Access Compliance Report

Public Rights-of-Way

(Curb Ramps)

Intersection ID: 31416	Main Street: BRAWER_FARM_DR	Cross Street: IRON_BRIGADE_LN	Location: S
ADA ID: 0FF74061775D	Ramp Type: PerpDiag	Initial Pass/Fail: Fail	Overall Compliance: No
Severity Score: 21.25			
Codes/Mitigation Info/Possible Solution		Field Measurements/Component Compliance

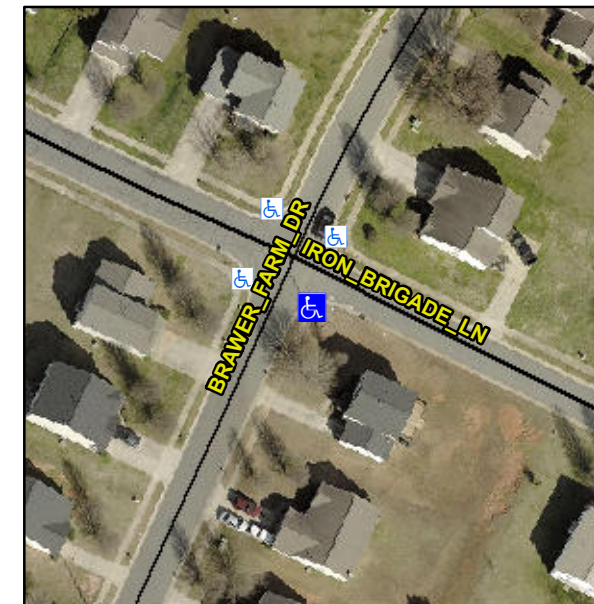
Not Found, R304.5.1, R304.2.2

Compliance	Description	Data	Compliance	Description	Data
N/A	Ramp Length (in)	48.5	No	Ramp Slope (%)	10.4
No	Ramp Width (in)	46.5	Yes	Ramp XSlope (%)	0.5
N/A	Flare Type LT	N/A	N/A	Flare Type RT	N/A
N/A	Flare Slope LT (%)	N/A	N/A	Flare Slope RT (%)	N/A
N/A	Flare Traversable LT?	N/A	N/A	Flare Traversable RT?	N/A
N/A	Landing Length (in)	N/A	N/A	DWS Provided?	N/A
N/A	Landing Width (in)	N/A	N/A	DWS Contrast?	N/A
N/A	Landing Slope (%)	N/A	N/A	DWS Length (in)	N/A
N/A	Landing X Slope (%)	N/A	N/A	DWS Full Width?	N/A
N/A	Landing Curb? (Y/N)	N/A	N/A	DWS Offset (in)	N/A
N/A	Shared Landing?	N/A			
N/A	Gutter Ponding?	Yes	N/A	Gutter Slope (%)	N/A
N/A	Gutter Lip Ht (in)	0.5	N/A	Gutter X Slope (%)	N/A
N/A	Painted X Walk1?	No	N/A	Painted X Walk2?	No
	X Walk 1 Direction	To E		X Walk 2 Direction	To W
N/A	X Walk 1 Width (in)	N/A	N/A	X Walk 2 Width (in)	N/A
	X Walk 1 Slope (%)	0.8		X Walk 2 Slope (%)	2.6
	X Walk 1 X Slope (%)	3.2		X Walk 2 X Slope (%)	2.1

Remove & Replace Curb Ramp With Two New Directional Ramps or Equivalent.
